RESEARCH REACTOR CENTER

REFERENCE: Docket 50-186
University of Missouri-Columbia Research Reactor
Renewed Facility Operating License No. R-103

SUBJECT: Written communication as specified by 10 CFR 50.4(b)(1) regarding responses to the
"University of Missouri at Columbia - Request for Additional Information RE: License
Amendment Request to Implement Selective Gas Extraction Target Experimental
Facility at the University of Missouri Research Reactor (CAC A11010/05000186/L-
2017-LLA-0227)," dated November 1, 2017

Below are MURR’s responses to the November 1, 2017, request for additional information (Questions 39 through 57), including enclosures of supporting documentation. Additionally, there is a correction to the response to RAI No. 3.3, which was submitted to the NRC by letter dated December 6, 2017.

Figure 40-1
Target Decay Heat Removal Valves Air Supply System

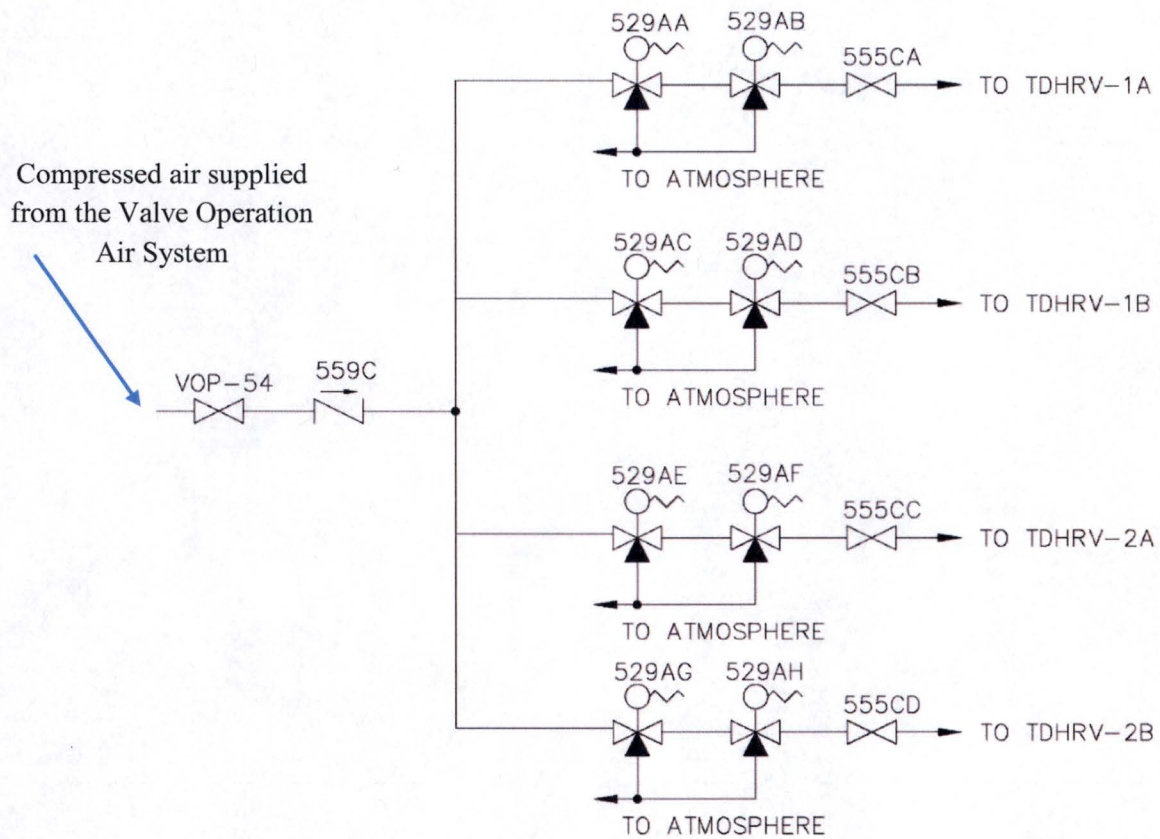
40.2. Discuss changes to any other auxiliary systems than the electrical system, needed to support the TEF operation, or justify why no additional information is needed.

As described in the response to RAI No. 40.1 above, operation of the Target Decay Heat Removal Valves (TDHRVs) will require compressed air from the Valve Operation Air System. Piping upstream of VOP-54 will be connected to the header that supplies compressed air to the reactor anti-siphon isolation valves V543A and V543B and in-pool heat exchanger automatic isolation valves V546A and V546B. Figure 40-1 shows the compressed air flow path from the existing Valve Operation Air System, and the solenoid-operated valves that will control compressed air to the TDHRV air-actuators.

Figure 41-1
Target Experimental Facility Cartridge Loading/Unloading Station (Side View)

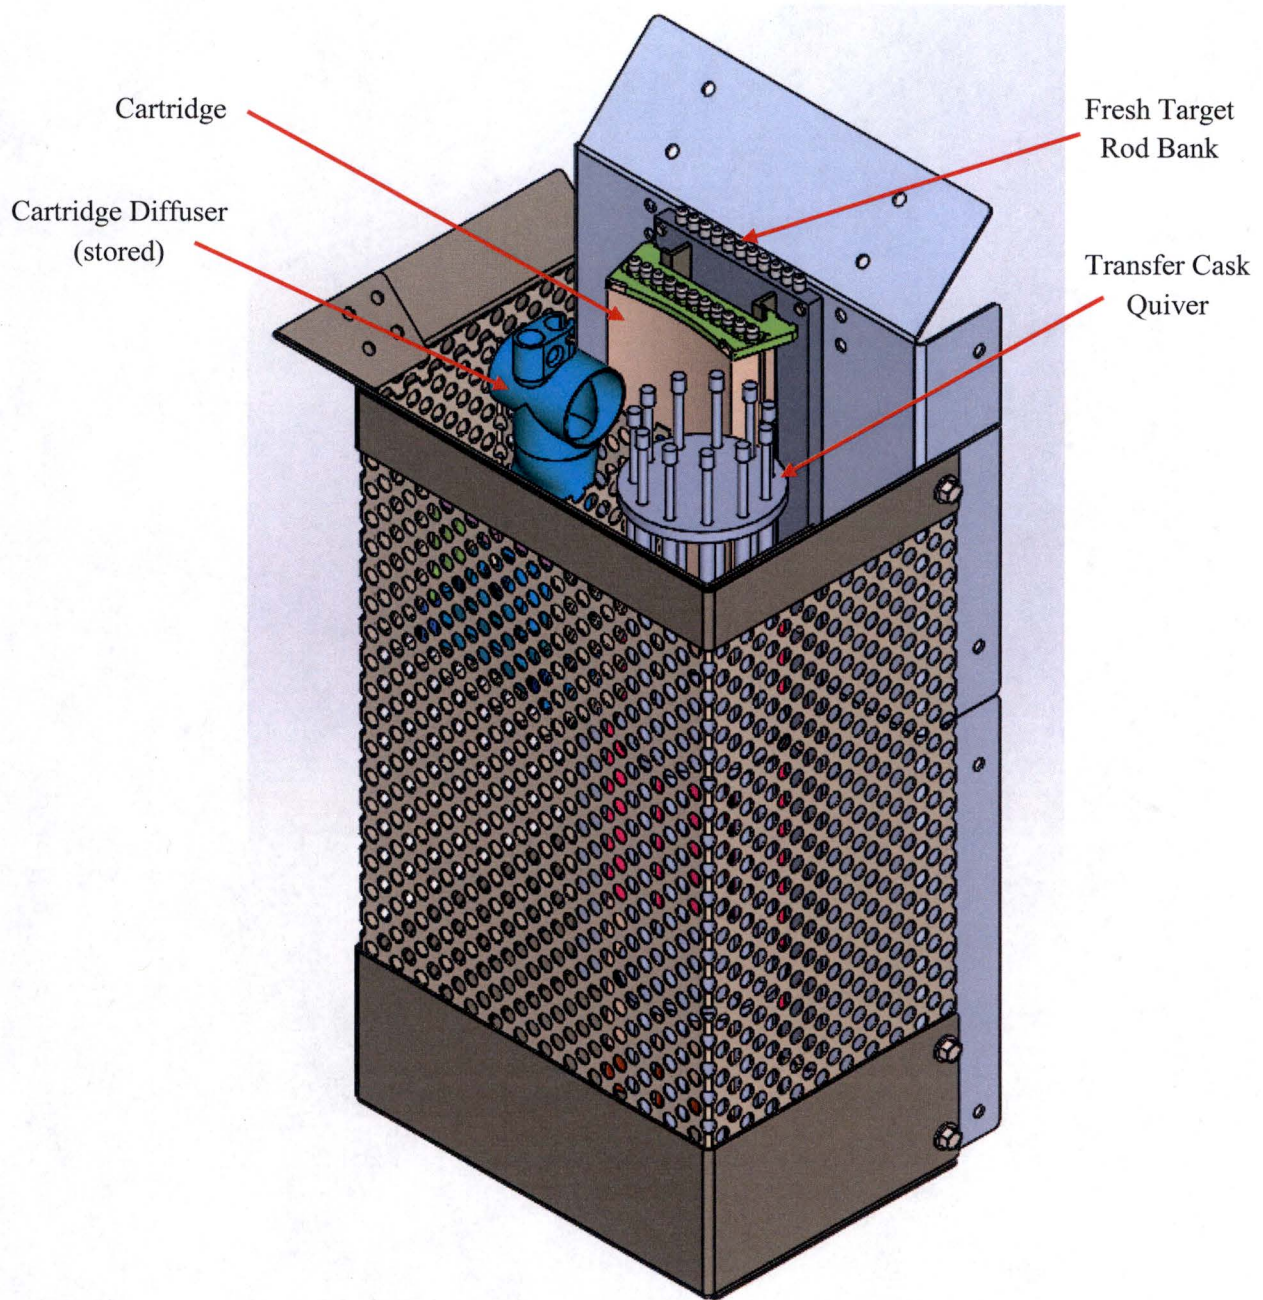
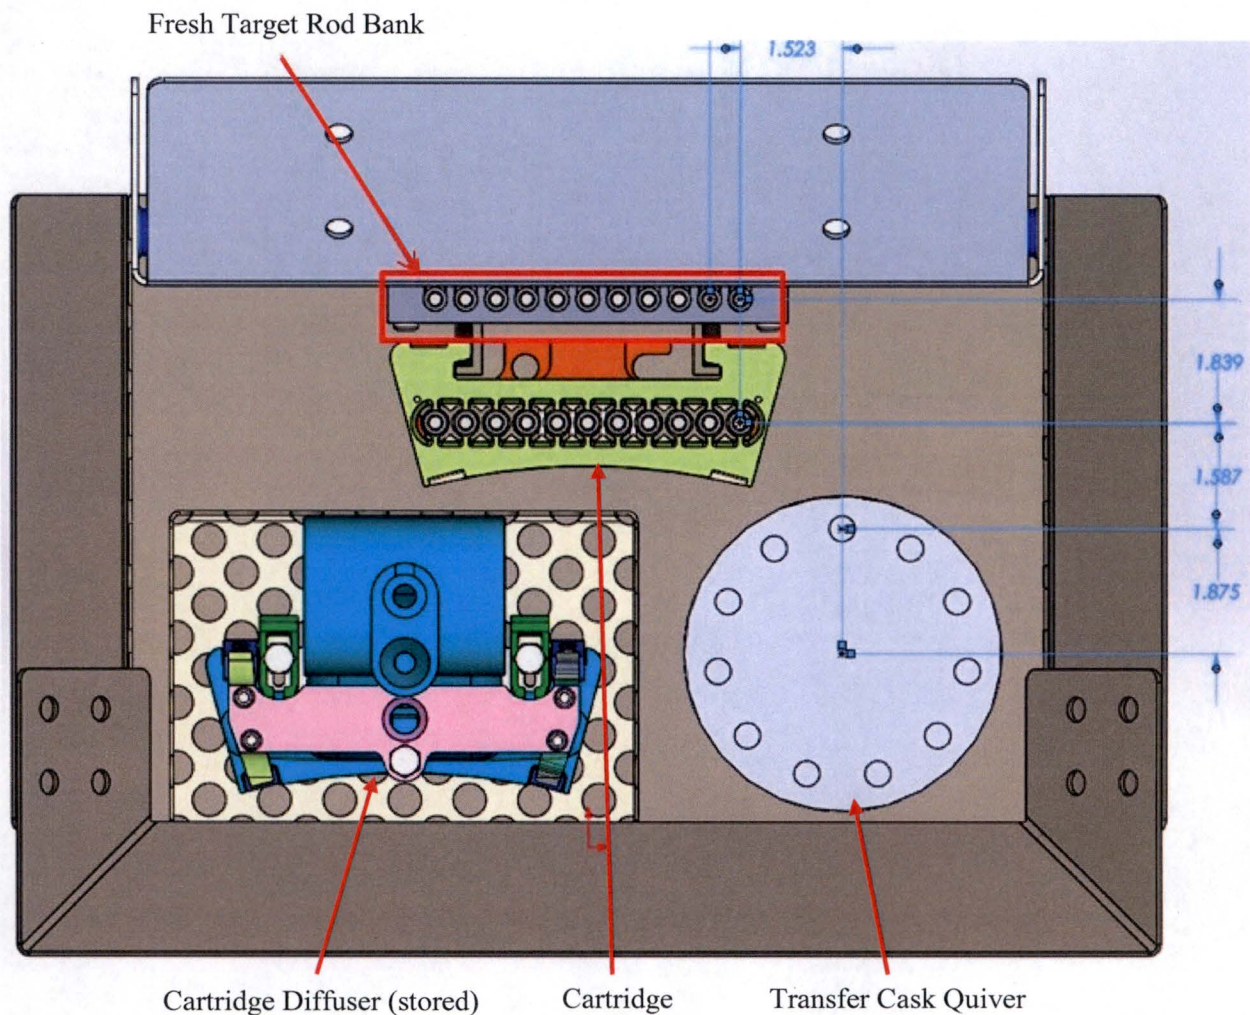
- 41.1. *Provide the detailed calculations that support the analyses for the k-effective values provided in the LAR, Section 7.1.1, "Cartridge Loading/Unloading Station Description," and the results of analyses for any other k-effective values reported in the LAR, or justify why no additional information is needed.*

Since submittal of LAR Part 1, the design of the Target Experimental Facility (TEF) cartridge loading/unloading station has been slightly modified to reduce its overall size. The station is now designed to only load/unload/store one (1) target cartridge at a time. The original submittal design allowed two (2) cartridges to be loaded/unloaded/stored at a time. A further explanation of the loading/unloading station will be included in the response to RAI No. 43. The new station design is shown in Figures 41-1 and 41-2. During a normal unloading/loading sequence, 11 fresh (unirradiated) target rods will be stored in the new target rod bank and 11 irradiated target rods will be in either the cartridge or the transfer cask (reactor pool to hot cell) quiver. However, to calculate the most conservative (highest) k-effective value for the unloading/loading station, the k-effective calculation assumed 33 fresh target rods were stored in the station; filling all possible target rod positions in the new target rod bank, the cartridge, and the transfer cask quiver.

The cartridge unloading/loading station criticality calculation was conducted using MCNP5 KCODE with the geometry and dimensions shown in Figure 41-2 with all 33 target rod positions filled with fresh (unirradiated) target rods. This calculation assumed the area around the entire station was flooded and surrounded by reactor pool water, which is the normal condition. The KCODE utilized 20 million source particles after rejecting the first 2 million particles. All cross-sections were acquired from the ENDF-V11.0 data sets. The results of the simulation for this configuration is a k-effective = 0.44309 with a standard deviation of 0.00018.

Figure 41-4
Selective Gas Extraction Target Housing-Handling Tool

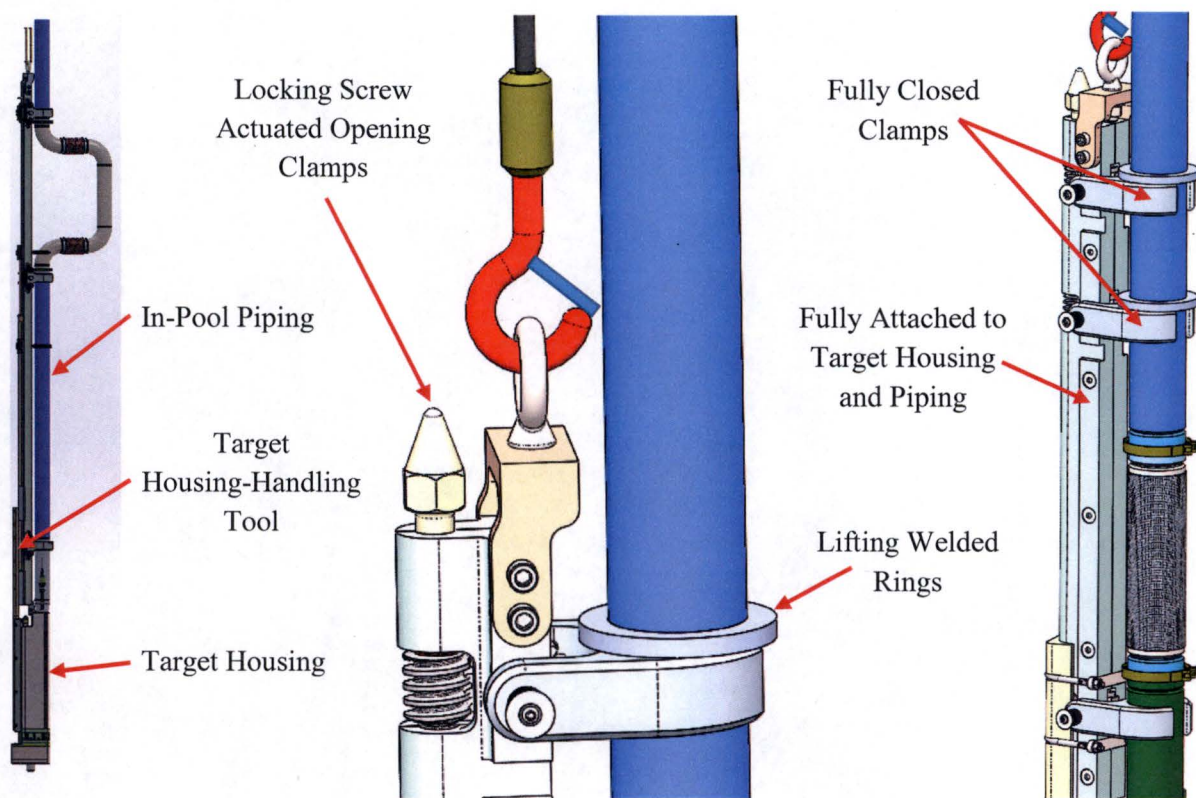
41.5. Provide a description of the tools needed for handling the target rods and cartridges, and the TAs (e.g., are the tools identical to the current fuel handling tools), or justify why no additional information is needed.

The SGE target housing-handling tool is designed to brace and attach on to the target housing and to secure the flexible bellows section of the piping (See Figure 41-4). For installation of the target housing, the tool is attached to the housing outside of the reactor pool in the same position normally occupied by the cartridge. The clamps are then engaged to the welded rings on the inlet pipe both below and above the flexible bellows section to secure and brace the flexible section. Using the crane, the target housing is then gently lowered into the pool adding the rest of the piping sections in succession as the housing is lowered. Once the target housing is safely installed in the graphite reflector region, the inlet pipe is secured to the refuel (lower) bridge of the reactor.

For removal of the target housing, the cartridge is first removed. Then, the same tool used for installation is lowered in the space normally occupied by the cartridge. Using the same guiderails used by the cartridge for alignment, the tool centers itself to the housing assembly. Once in position, the bolt that engages the clamps is actuated to grab the lifting welded rings on the target housing piping. At this point, the housing is secured to the lifting tool such that the piping is released from the bridge brace. The target housing is then slowly lifted out of the reactor pool removing the piping as the flanges come out of the water.

Figure 43-1
SGE Target Rod-handling Tool

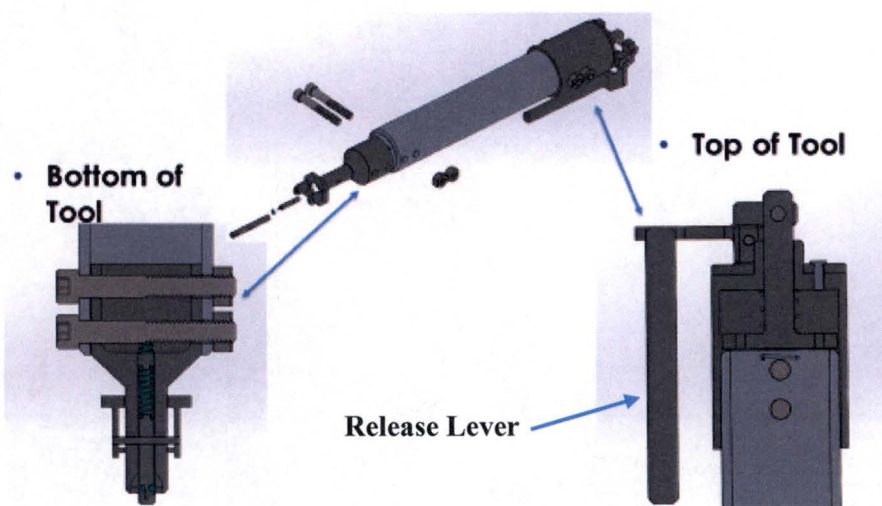
Provide additional description, detail, drawings, illustrations, etc., of the TA cartridge loading and unloading station operation, and the cartridge installation and removal into and from the target housing, and storage, or justify why no additional information is needed.

When an SGE target rod is to be handled, the SGE target rod-handling tool release lever is actuated by the operator's hand overcoming the compression spring force to allow the female end to slide over the end of the target rod with the captive locking ball disengaged (See Figure 74 in LAR Part 1, Attachment 1, and Figure 43-1 below). The SGE target rod-handling tool is then lowered over the target rod. Once the tool is fully engaged on the target rod, the release lever is released. The compression spring then forces the captive locking ball to be lodged such that the inner male end of the SGE target rod-handling tool is locked to the inside surface of the target rod. The captive locking ball maintains positive engagement of the SGE target rod-handling tool to the target rod until the release lever is again actuated.

Figure 47-1
LAR Part 1 Flow Path for the SGE Target Rods

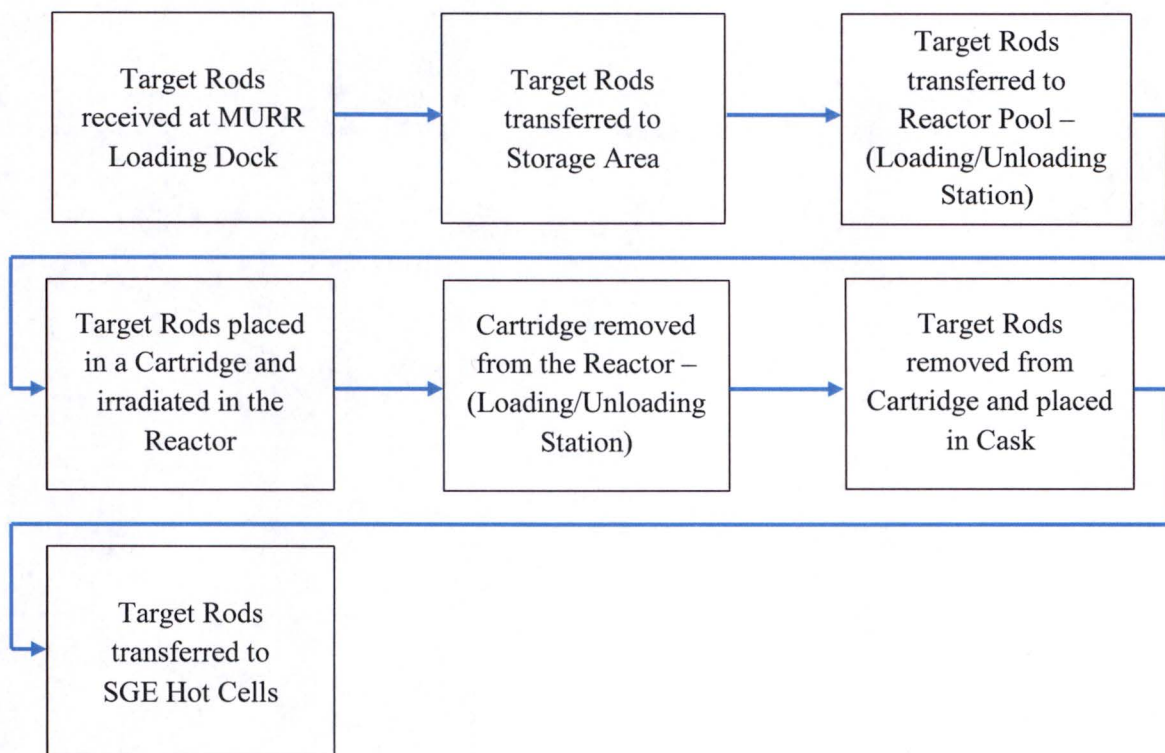
Provide a description of the material controls required for the irradiated targets as described within the scope of the activities proposed in the LAR, Part 1, or justify why no additional information is needed.

The entire Special Nuclear Material (SNM) Material Control and Accounting (MC&A) program for this project spans both LARs Part 1 and Part 2. Therefore, it is planned to have a single MC&A program that covers the entire process.

Figure 47-1 below is the LAR Part 1 flow path from when the SGE target rods are received at MURR, through the irradiation process, and to the point when they are placed in the pool-to-hot cell cask for their transfer from the reactor pool to the processing hot cells.
